Model: Russian-C3			Dat	ate: 28-Nov-03		No.: RB089001
Subject: Firmware Release History (SBCU)			Prepared	d by: Y. C	Ohtani	
From: 1st Tech. S	Support Sec. Service Support D	Dept.				
Classification:	☐ Troubleshooting	☐ Part info	ormat	tion	Action	required
		☐ Electric	al		☐ Service	e manual revision
	☐ Paper path ☐ Transmit/r		it/rec	eive	☐ Retrof	fit information
	⊠ Other ()

This RTB has been issued to announce the firmware release information for the SBCU Firmware Service Card.

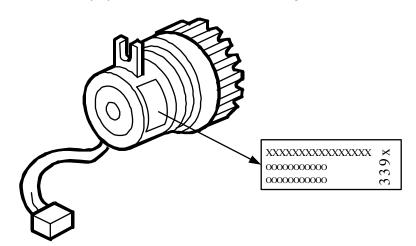
During factory tests in Japan, a non-paper feed jam was observed when feeding thick paper types on a limited number of machines (i.e. only some machines fitted with lot 339 paper feed clutches).

Some paper feed clutches produced in lot 339 may not produce the necessary torque.

The clutch vendor has improved the inspection processes to further ensure clutches are produced in accordance with specifications.

If a non-feed jam is reported from the field, replace the paper feed clutch with one from <u>before or after</u> lot 339.

- Lot number labels are attached to the clutch (see illustration below).
- Lot 339 paper feed clutches are no longer in stock at SPC Japan.

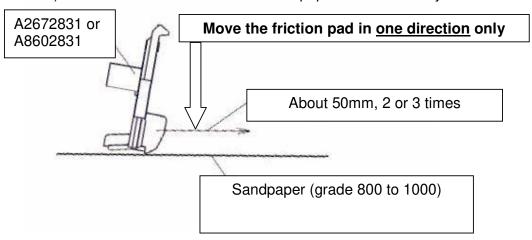
Cav 1: Normal

Cav 2: May be defective

2. If it is suspected that the non-feed <u>is caused</u> by a defective friction pad, please try the following:

(1) Replace the friction pad.

- (2) Remove the burr with grade 800 to 1000 sandpaper
- Smoothing the friction pad surface with grade 800-1000 sandpaper:

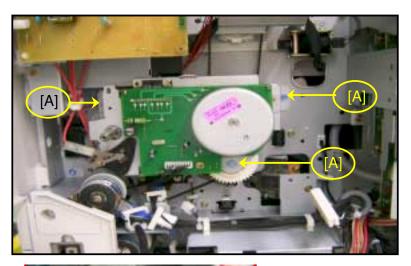
If you find this problem, correct the position of the main motor. Follow the procedure below:

- 1. Remove the connector cover [A] (snap holder) and the rear cover [B] (4 screws).
- 2. Disconnect all connectors [C] for the SBCU board (14 connectors).
- 3. Remove 4 screws [D] securing the SBCU board bracket, then swing down the board bracket [E].

- 4. Remove the flywheels [F] (1 screw).
- 5. Slide out the main motor [G] (3 screws).
- 6. Reinstall the main motor. Make sure the bushing is correctly positioned as shown in the pictures below (also see page 2 of this RTB):

Old clutch (B0911186)

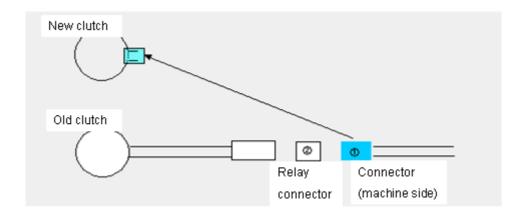
Change: The shape and harness wiring of the clutch were changed.

Reason: Vendor change

Important: When you install the new clutch for the first time, remove the relay connector and connect the clutch directly to the machine-side connector, as shown below:

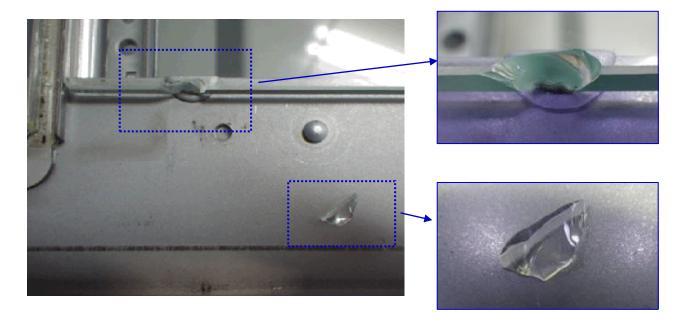
The Exposure Glass is damaged at the front side as shown below.
